SERVICE TECHNICAL INFORMATION

ONE POINT REPAIR

REF.NO. : S1-95-015
CUSTOMER RELATION & SERVICE DIV.

- MODELS : LCX-50, LCX-AP1
 SUBJECT : Does not display
 SYMPTOM : In the LCX-50, there are cases in which the display stops functioning. If such symptoms are indicated by the customer, perform the following remedy. (Please disregard Service Technical News G-94-40.)
 REMEDY : Change the chip condenser of the front P.C.B.
 (1) Ref. No. C18 C-CAP 0.033 μF -> C-CAP 0.022 μF BK (capacity change)
 (2) Ref. No. C21, 24 CAP M 0.1 μF -> C-CAP 0.1 μF (change from mylar to a chip material)

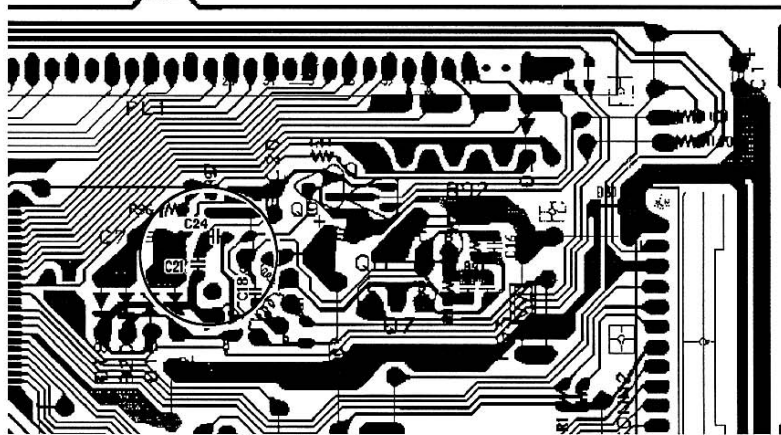
- NOTES
- Applicable production lot: 11/94 ~ 2/95 (Mylar condensers C21 and 24 are soldered on the rear side of the P.C.B.)
 - Perform only remedy (1) for models produced before 11/94.
 - For boards with sever burns around the DC-DC converter, replace the front P.C.B.

Ref.	部品名	部品番号
C18	T-CAP 0.022 μF	87-010-198-089
C21, 24	T-CAP 0.1 μF	87-010-196-089
-	DISPLAY CB	SV-T00-012-010
